**CITY OF BLOOMINGTON
PLAN COMMISSION AGENDA
Oct. 8, 2012 @ 5:30 p.m.**

**BLOOMINGTON PLAN COMMISSION
SECOND HEARING STAFF REPORT
Location: 217 W. Kirkwood Avenue**

**CASE #: SP-36-12
DATE: October 8, 2012**

SAB
RJB
9/14/12
3 of 9
SITE PLAN

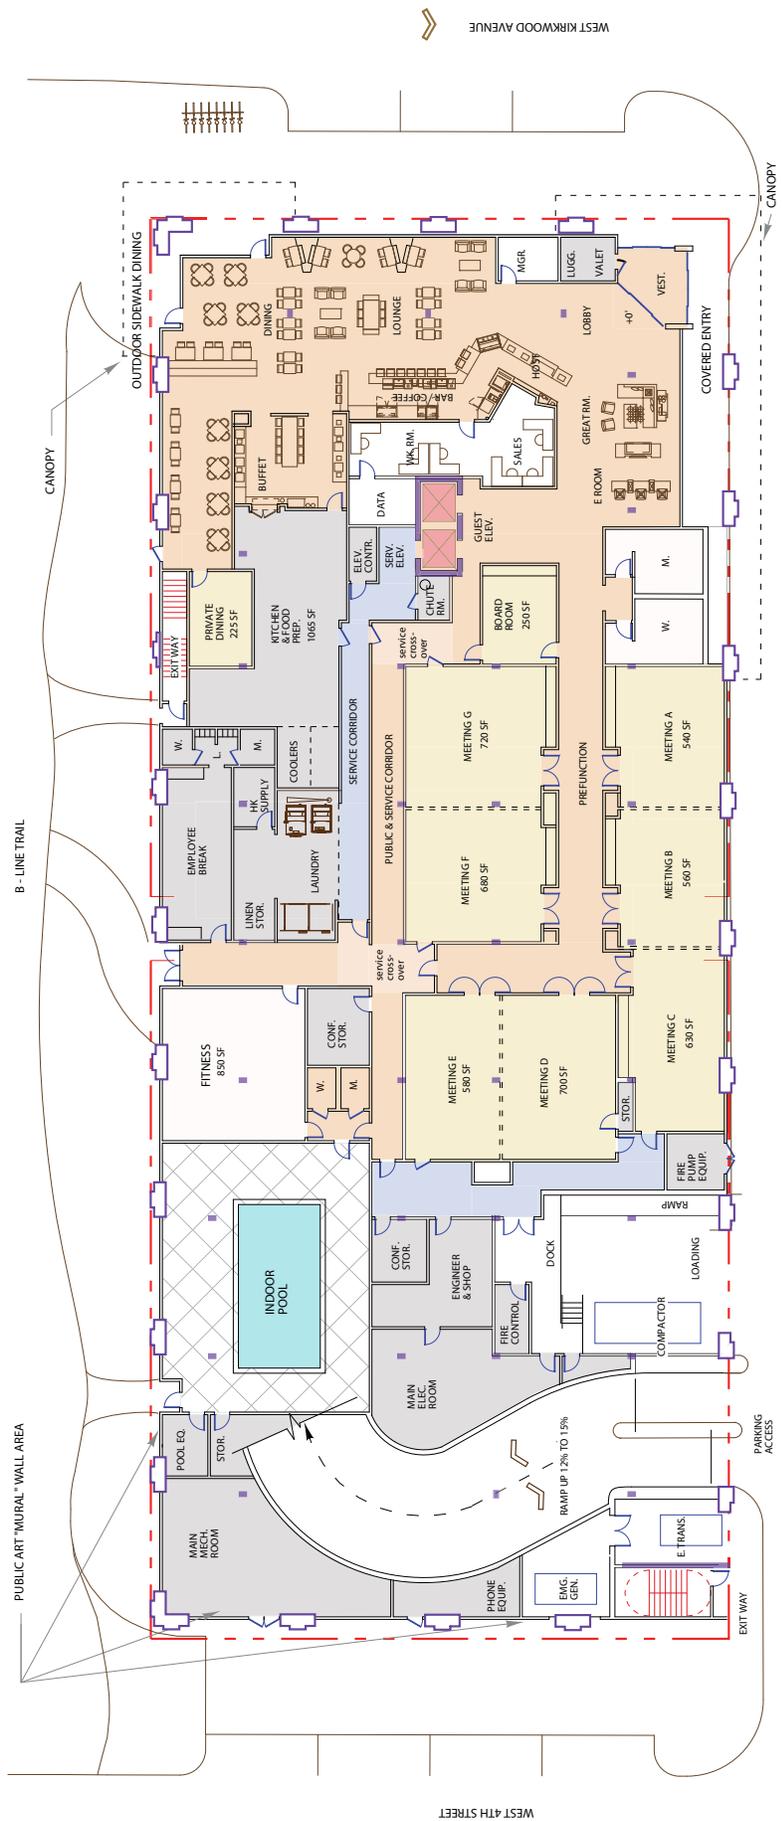
The petitioners have revised the site plan to increase the drive width along Kirkwood to 18 feet. They have also altered the drive cut along 4th St. to 14 feet and are proposing to improve the pedestrian crossing on both sides of Gentry to achieve better pedestrian flow. The Engineering Department has recommended that this drive along 4th Street also be widened to 18 feet.

Staff has further analyzed the possibility of placing sidewalk along the west side of Gentry Street to the east. The inclusion of such a sidewalk is not advisable due to a lack of adequate right-of-way and the desire to allow for two one-way lanes of traffic. The existing street has between 35 and 41 feet in pavement width. However, the right-of-way is only 20 feet in width. So although there appears to be plenty of room for a sidewalk, the street will be reduced to approximately half of its existing width. This will also necessitate the removal of approximately 4 parallel parking spaces on the east side of Gentry.

Staff finds that the proposed configuration is the best alternative. The 20 feet of pavement will allow loading without blocking the street. This configuration would create essentially a hybrid between a street and an alley. It will be one-way and have two lanes, one of which will often be used for loading. It will also have a sidewalk on one side (east). The existing sidewalk to the east is 20 feet from the proposed building. If an additional sidewalk were

1. The petitioners must stripe a loading zone along Gentry Street.
2. The southern drive cut off 4th Street must be modified to 18-feet in width.
3. The petitioners must work with City Engineering to install a parabolic mirror or equal treatment at the garage exit on Gentry St.

East Elevation

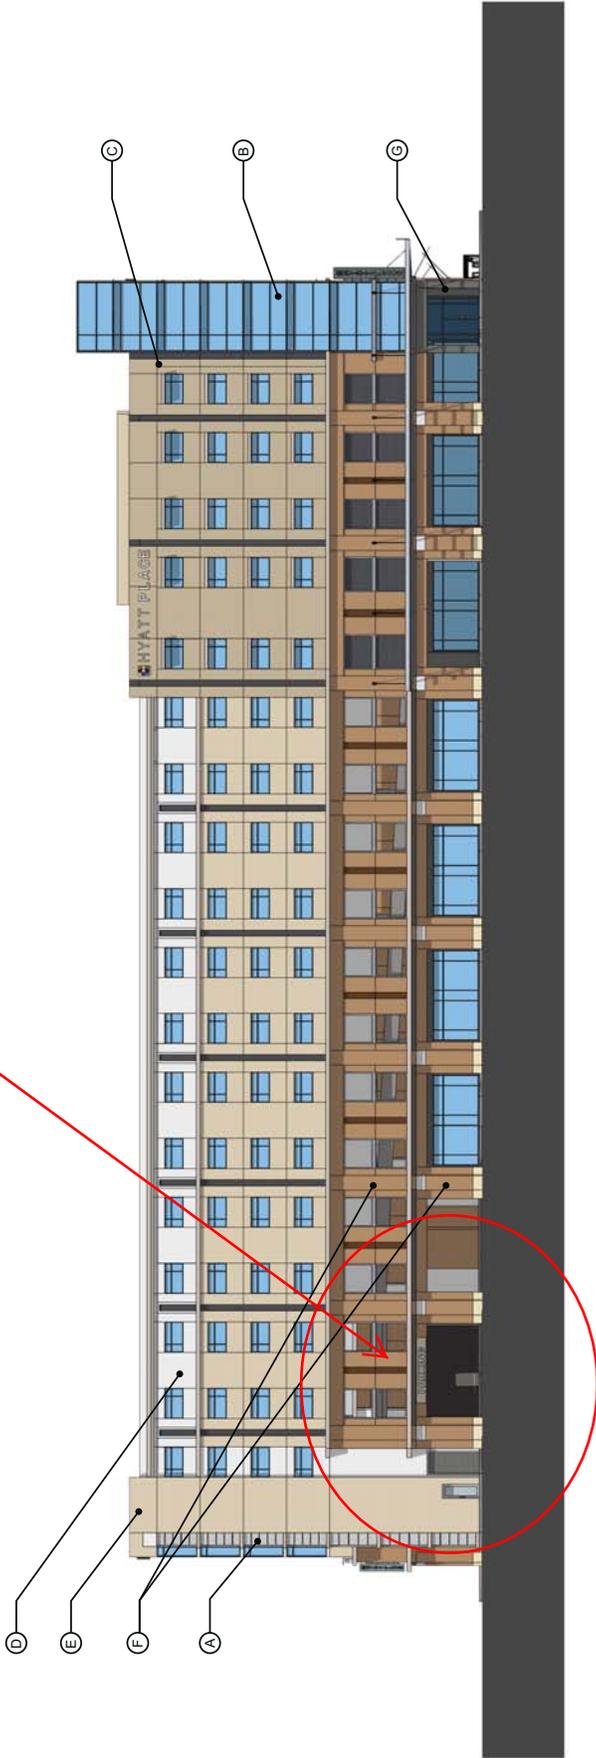
Pedestrian Entry Waiver – 20.03.060(a)(3)(B): Similar to the lack of void-to-solid on the 4th St. elevation, the utilitarian nature of the southern portion of the building is driven by the desire to place the parking on the upper levels of the structure and placing an aesthetic priority on the Kirkwood Ave. and B-Line Trail elevations. The other entries meet all of the goals envisioned by the Downtown Plan.
